**SUBJECT: COMANCHE PEAK STEAM ELECTRIC STATION (CPSES)
DOCKET NOS. 50-445 AND 50-446
TRANSMITTAL OF COMANCHE PEAK STEAM ELECTRIC
STATION (CPSES) EMERGENCY PLAN, REVISION 32**

CPSES Emergency Plan – Revision 32

Summary of Changes

FIGURE 1.6

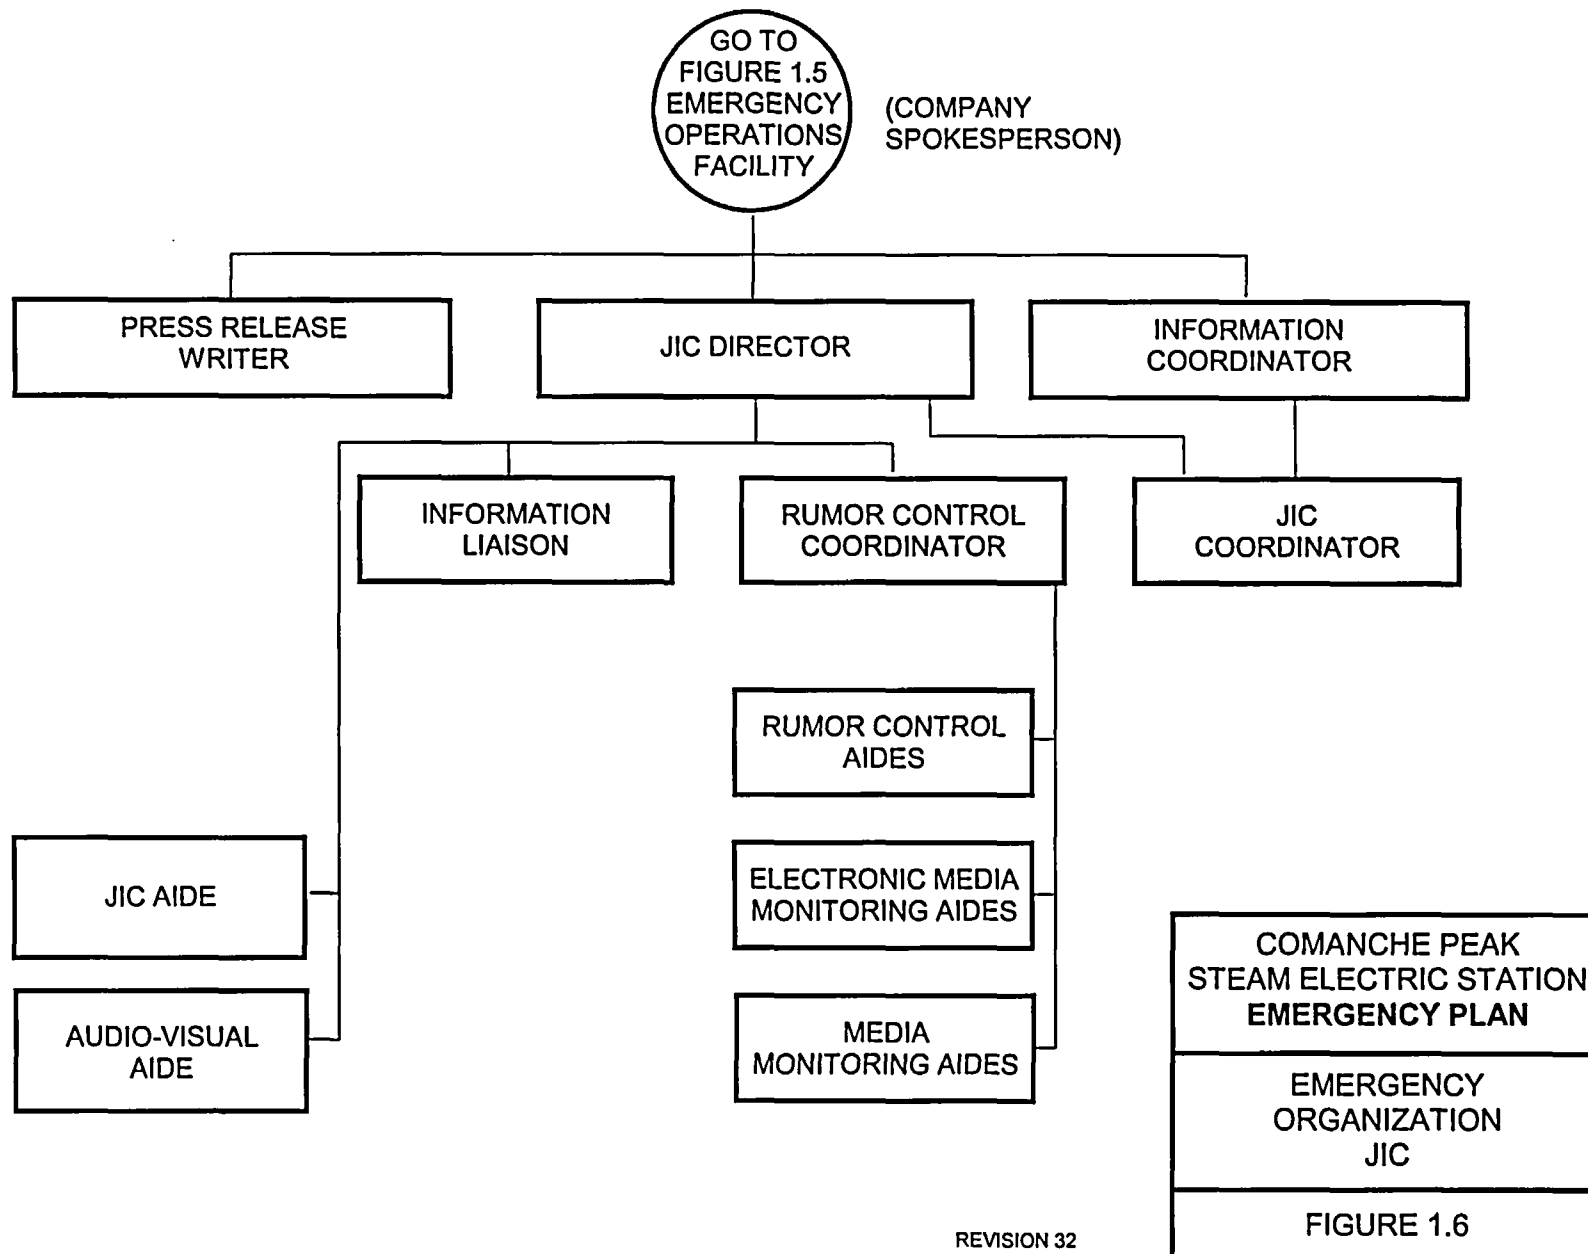
Fig 1.5, Fig 1.6	Change from onsite News Center to offsite Joint Information Center (JIC)	As previously discussed.
3-3	Update siren count to 72 Update from company name from TXU Energy to TXU Power	Alert and Notification System changes have been reviewed by FEMA with no potential negative impacts identified. As previously discussed.
4-1, 4-2	Update description of the Gaitronics System to reflect modification of one (1) channel as a dedicated Control Room (CR) paging channel.	This modification does not reduce the overall number of channels used by the system, but does change the use of one channel to become a dedicated CR paging channel. This mod was performed to reduce the background noise and distractions presented to CR operating staff.
